**MARICOPA COUNTY**  
*Department of Transportation*

**Subject:** Delete the use of Asbestos-Cement Pipe in Valve Box Installations **Case 14-11**

**PURPOSE:** Delete the use of Asbestos-Cement Pipe (ACP) in new Valve Box Installations.

DETAIL NO.  
391-2

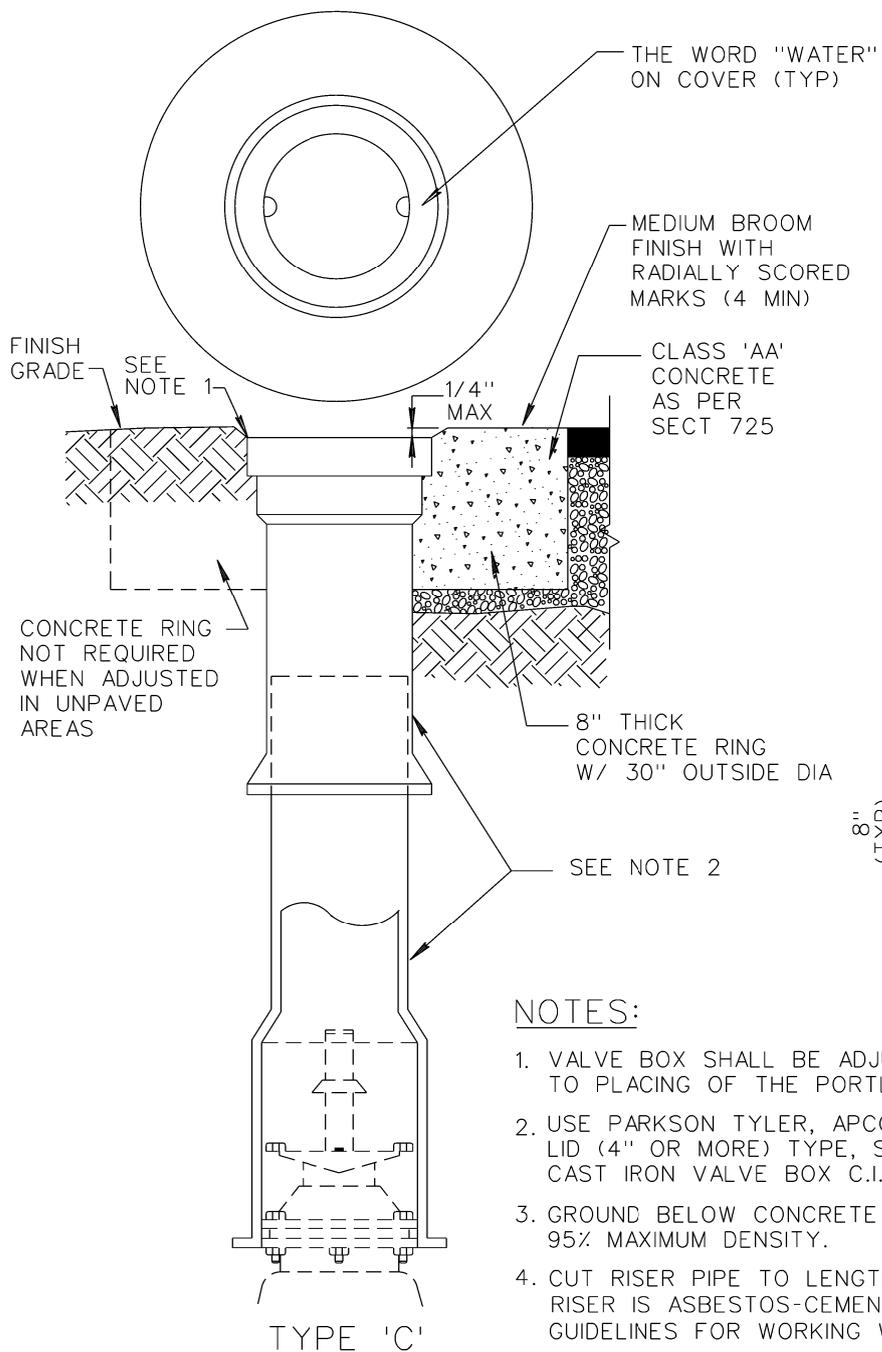
**Detail 391-2, Revised the first sentence of Note 2 to read:** If two or more sections of pipe are used to make the valve box riser, they shall be coupled or bonded to form debris-tight joints.

DETAIL NO.  
391-1

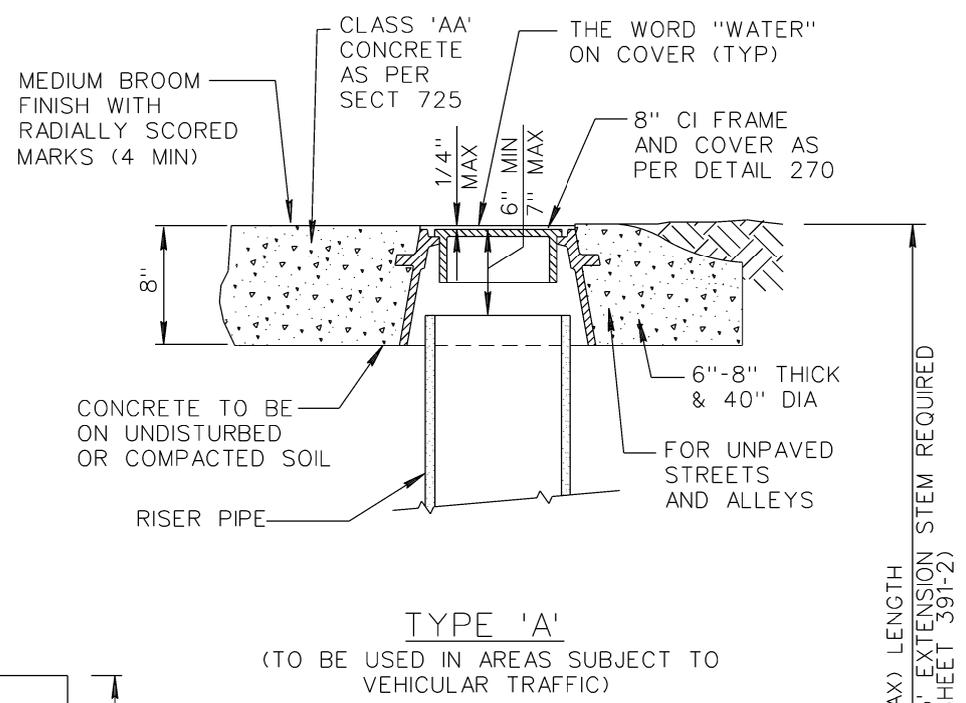
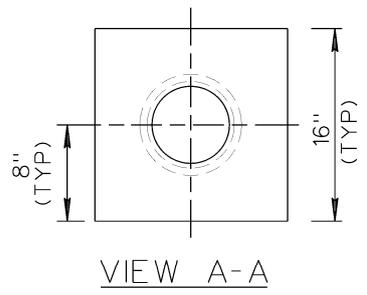
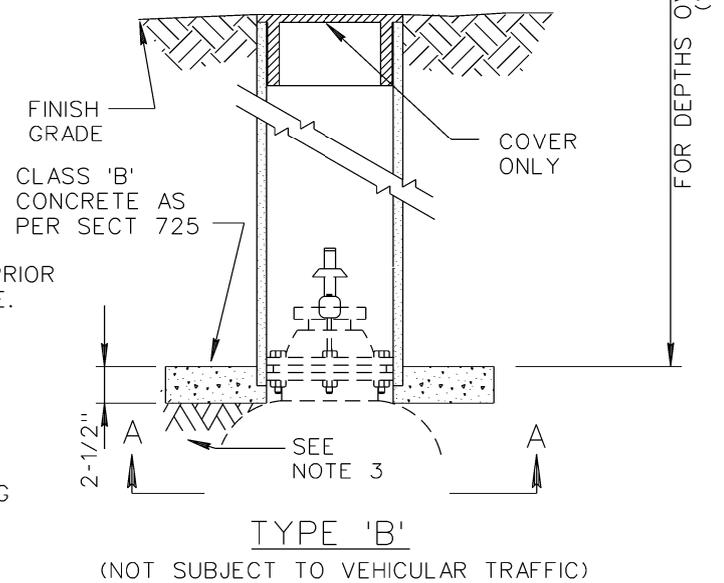
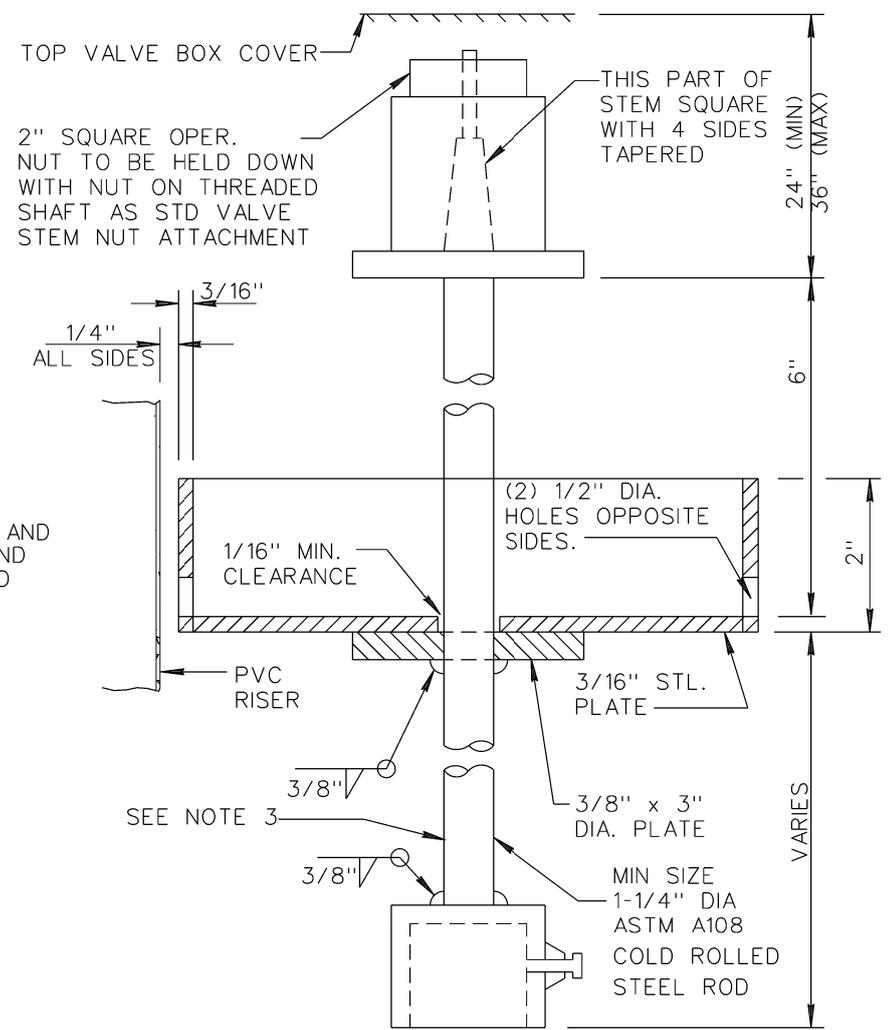
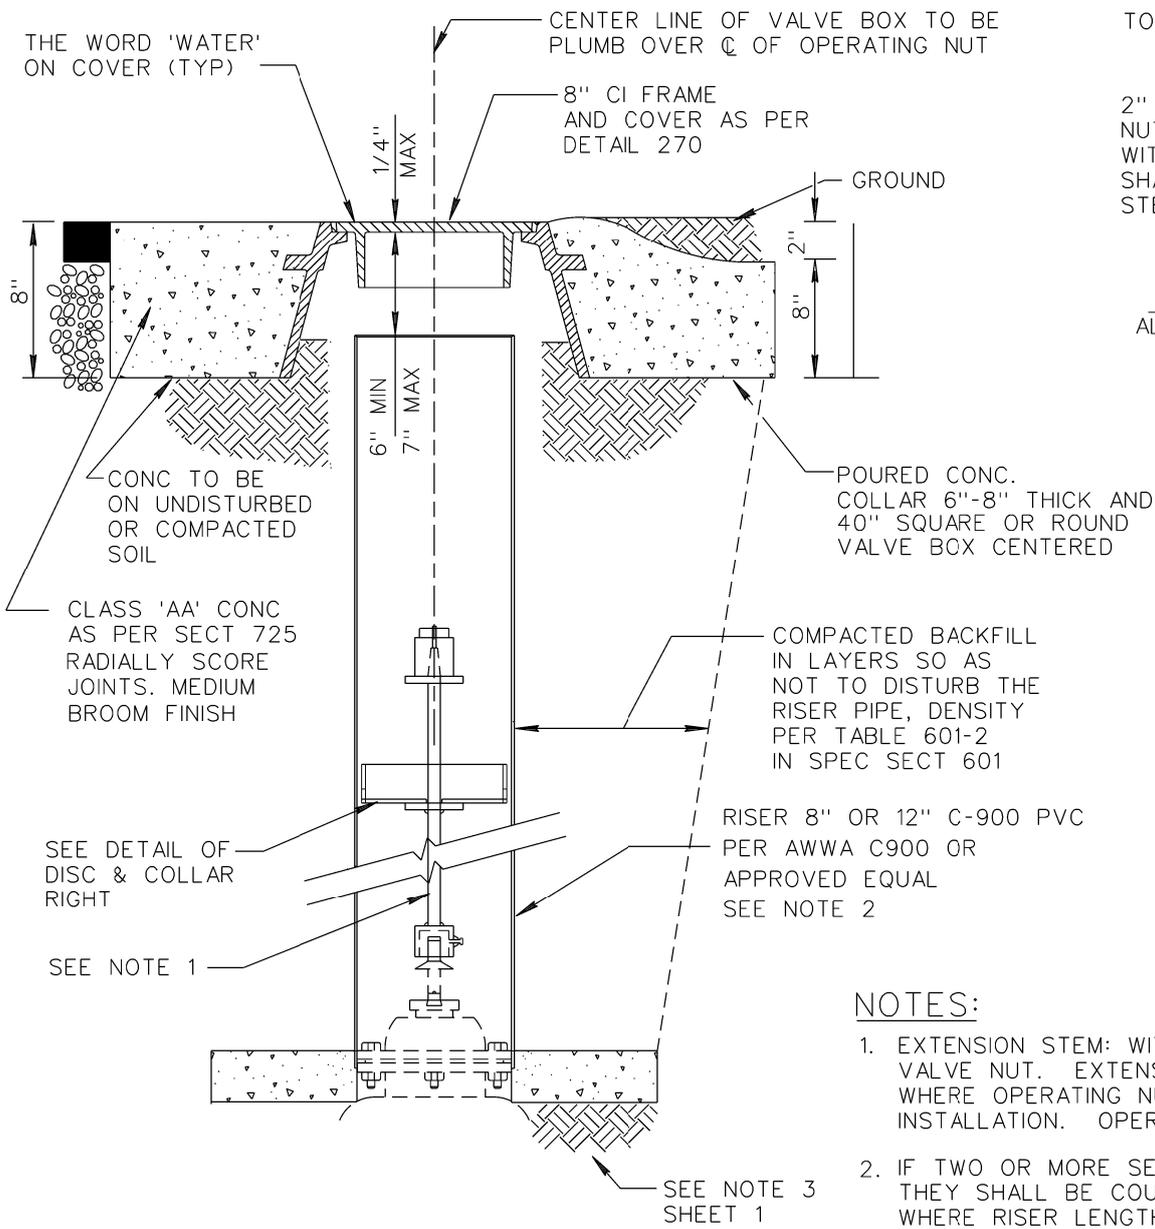
1. Replaced ACP with PVC C900 pipe or approved equal.
2. Pictorial adjustments made to Details 391-1, 391-2, and 392.
3. Deleted the brick alternative for supporting the valve box riser pipe.

**Detail 391-1 Added Note 4:** Cut riser pipe to length in field. Caution: If existing riser is asbestos-cement pipe (ACP) follow OSHA guidelines for working with ACP.
